**ADDENDUM NO. 1
TO CONTRACT DOCUMENTS FOR THE
LIVE OAK RESTORATION REACH PROJECT
Project No. 91864005 Contract No. C0726
Invitation No. VW0669**

C0726 – LIVE OAK RESTORATION REACH PROJECT

Revised Plans: Sheets G-02, G-03, G-04, G-05, G-06, G-07, G-08, G-09, G-10, G-11, G-12, D-01, D-02, D-03, D-04, D-05, D-06, D-07, V-01, V-02, V-03, V-04, C-01, C-02, C-03, C-04, C-05, C-06, C-07, C-08, C-09, C-10, C-11, C-12, C-13, C-14, C-15, X-01, X-02, X-03, X-04, X-05, X-06, X-07, X-08, and X-09

SCALE AS SHOWN	PROJECT NUMBER: 91864005
VERIFY SCALES	SHEET CODE: G-09
0 1" BAR IS ONE INCH ON ORIGINAL DRAWING IF NOT ONE INCH ON THIS SHEET, ADJUST SCALES ACCORDINGLY	SHEET NUMBER: 9

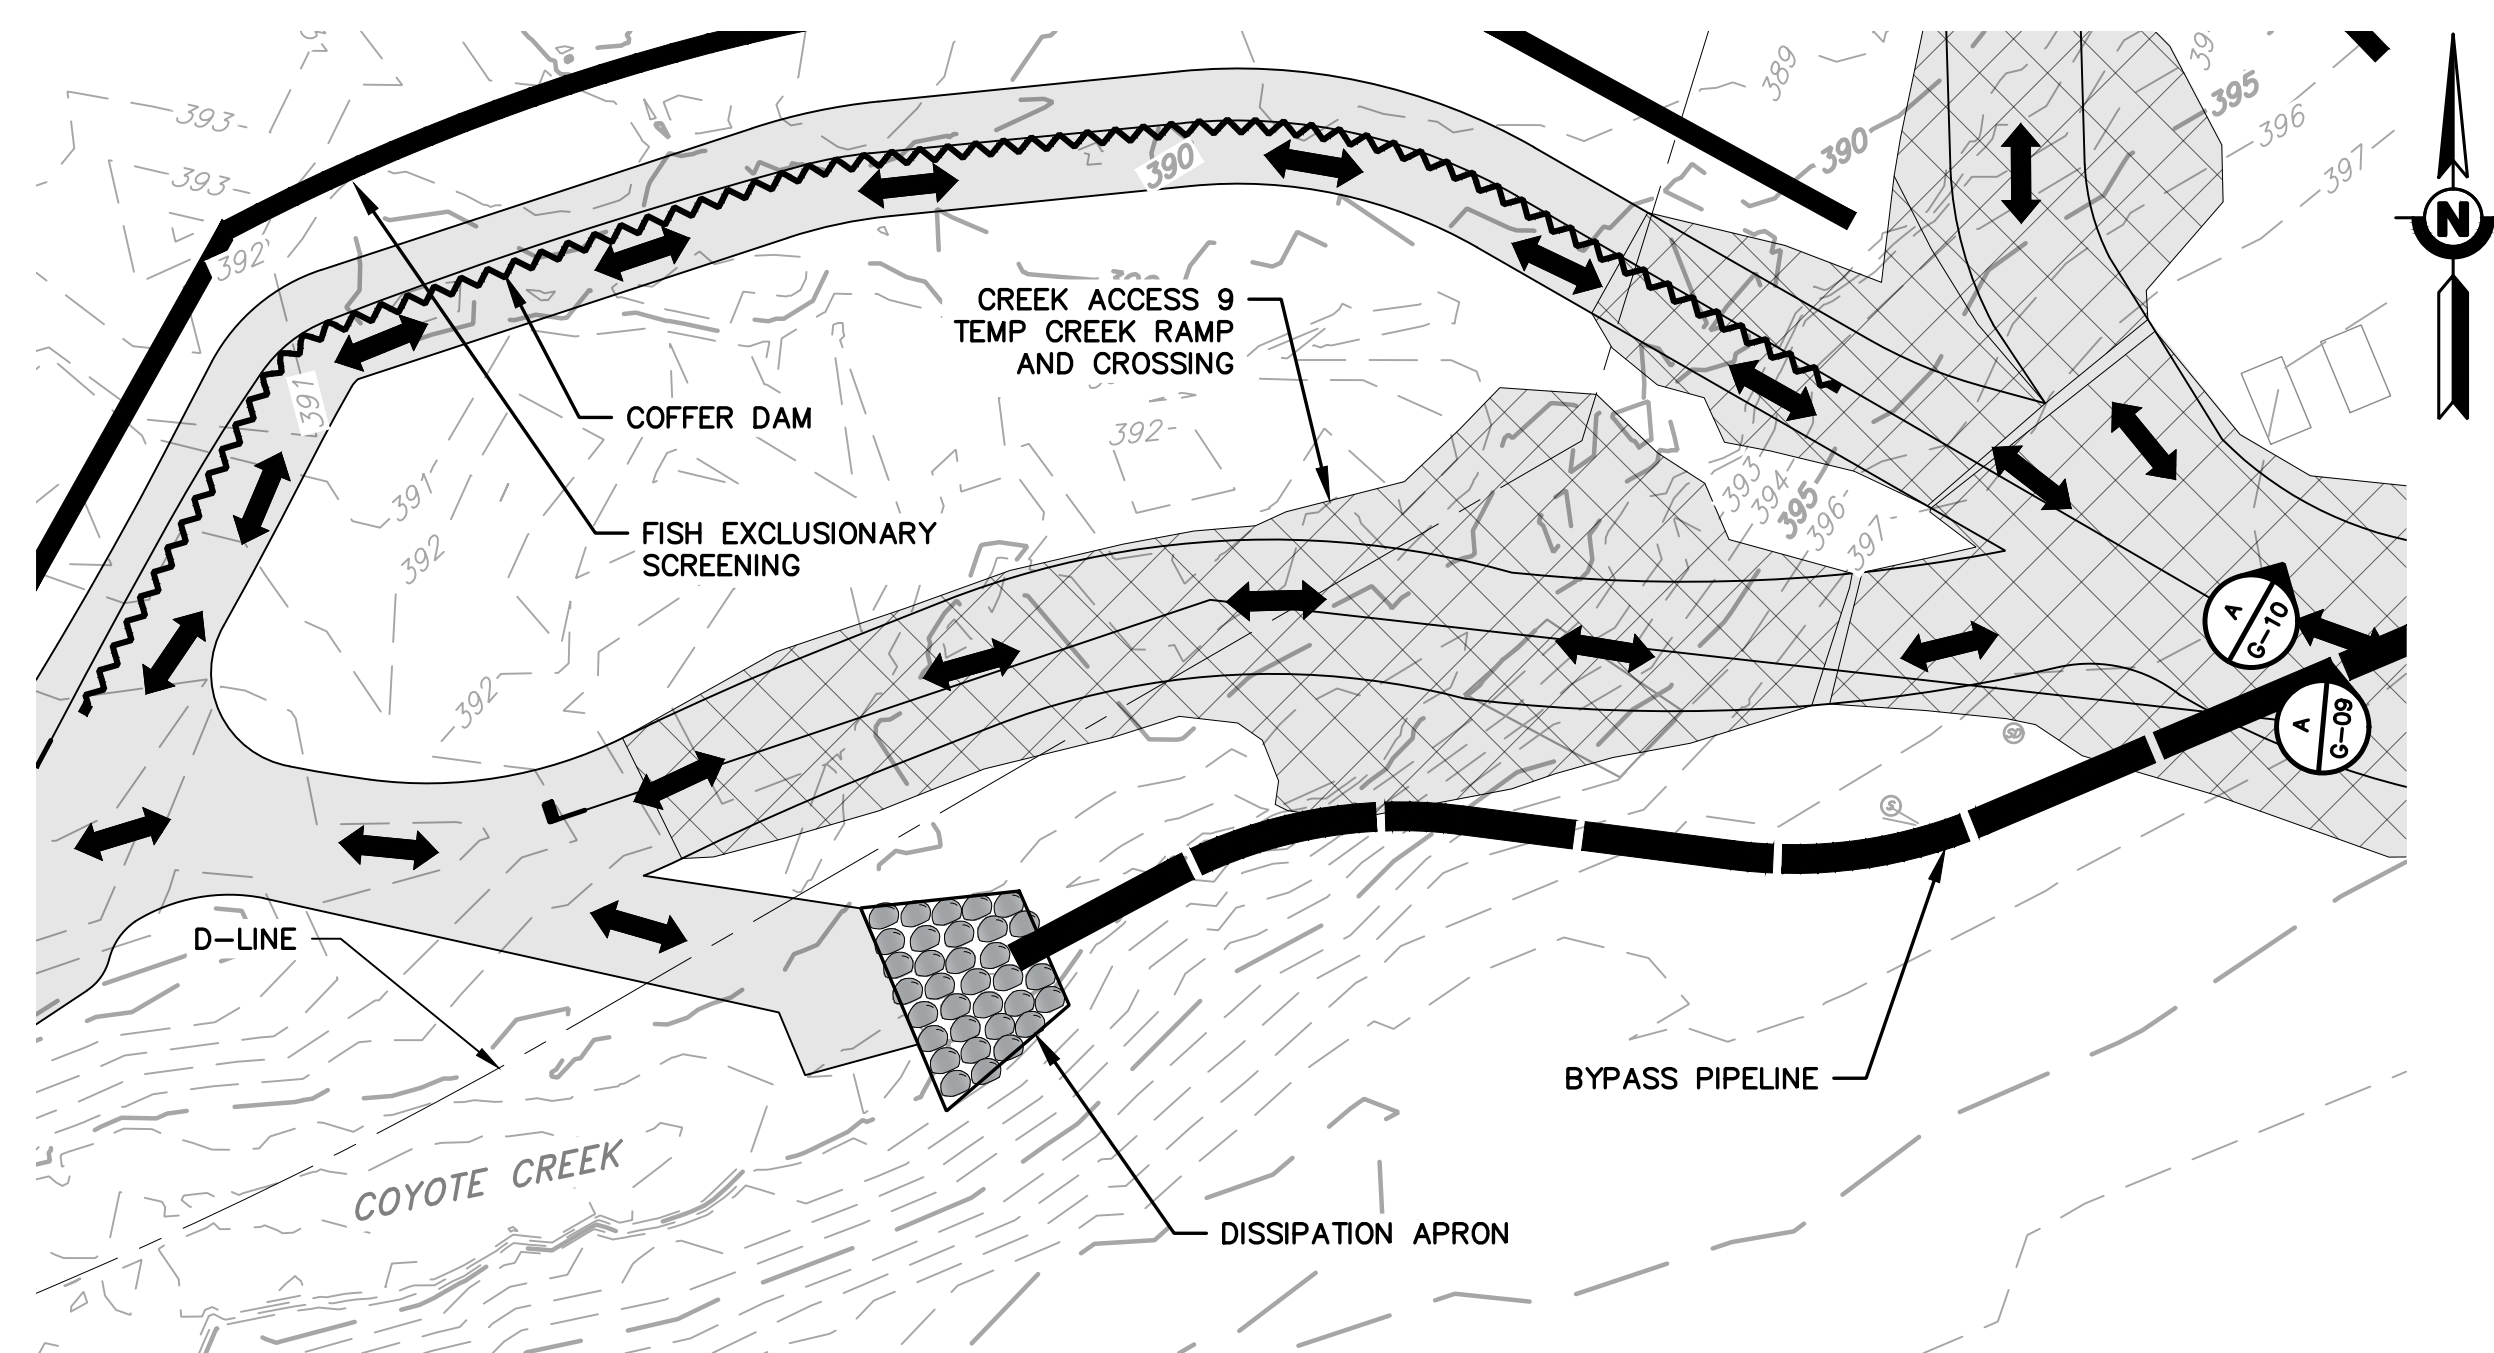
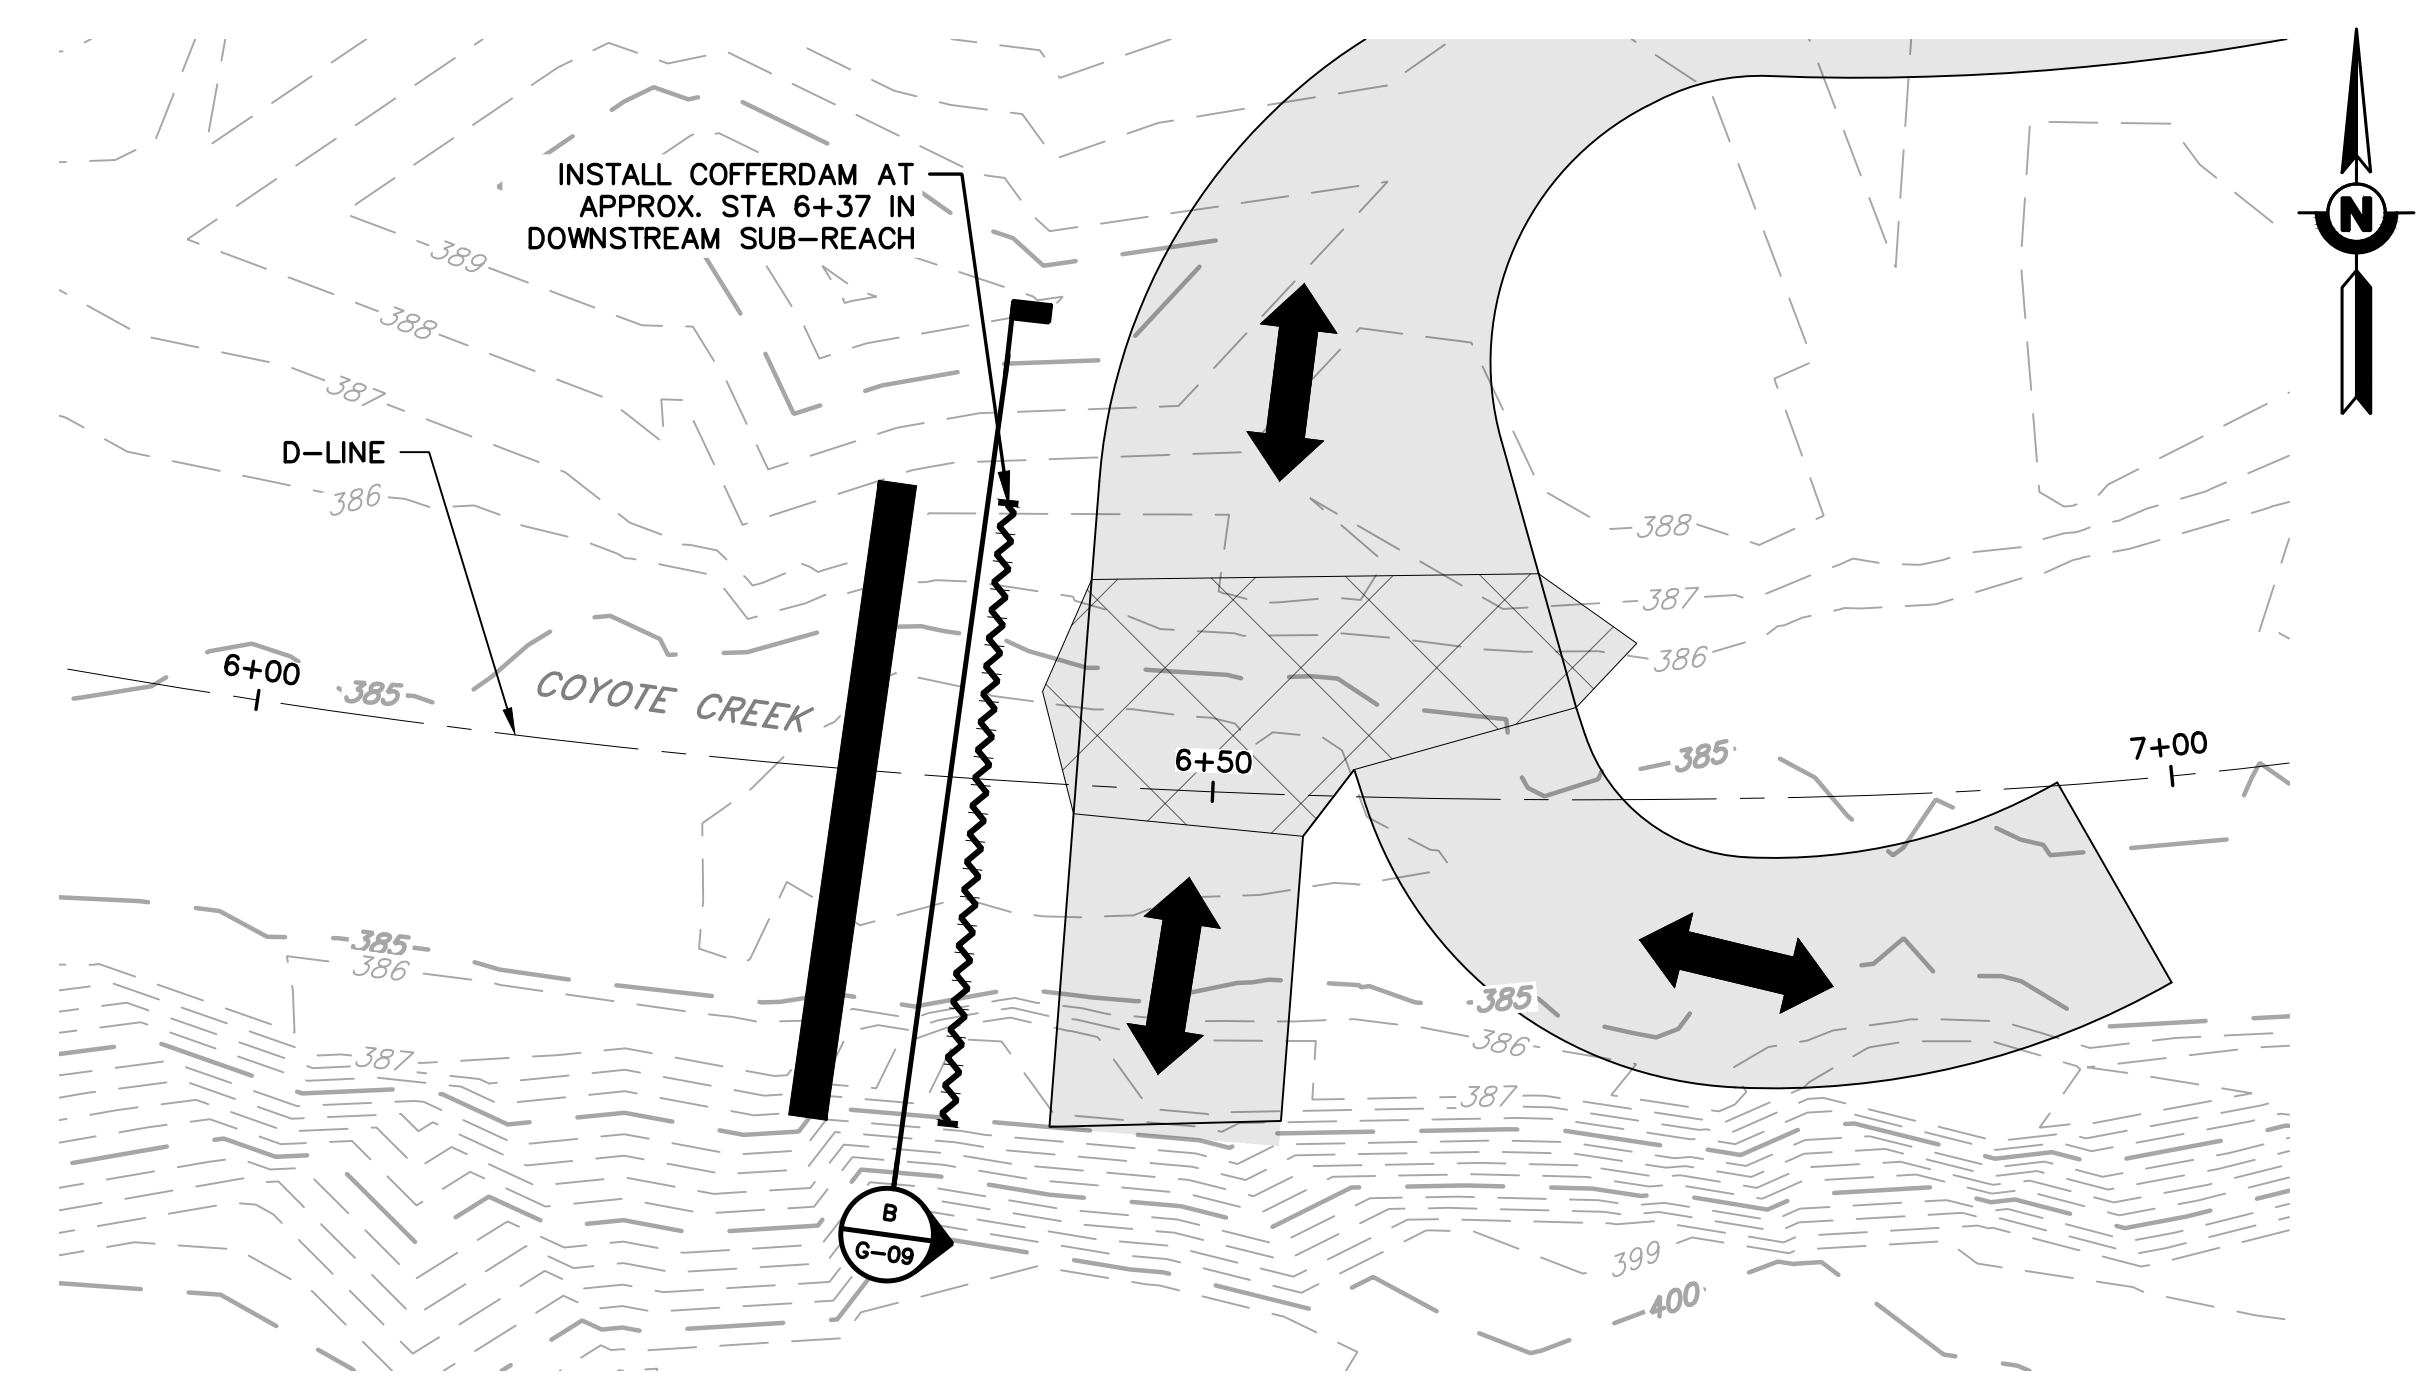
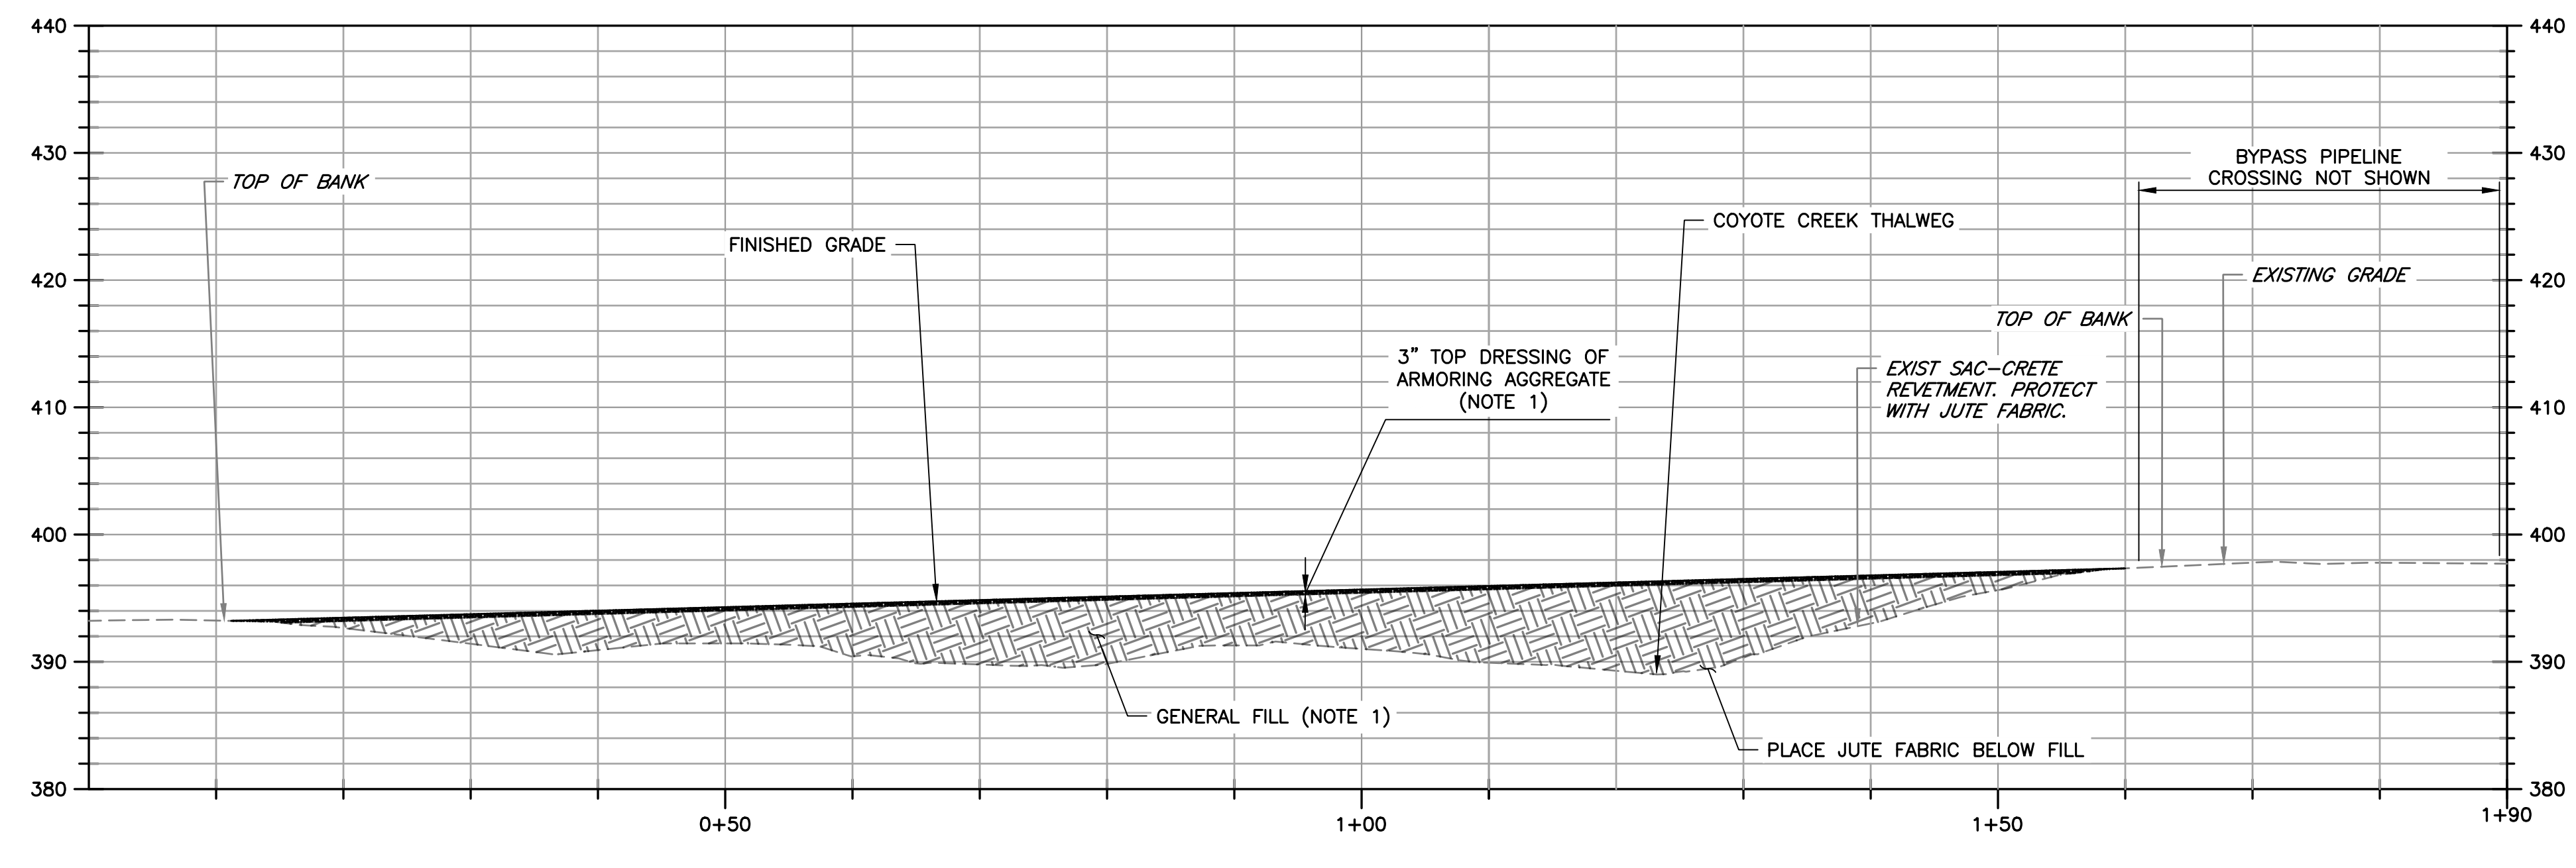
QUESTION 4: (Date Received – April 28, 2026)

Please see Sections on Plan Sheets G-08 through G-12 for installation of Armoring Aggregate.
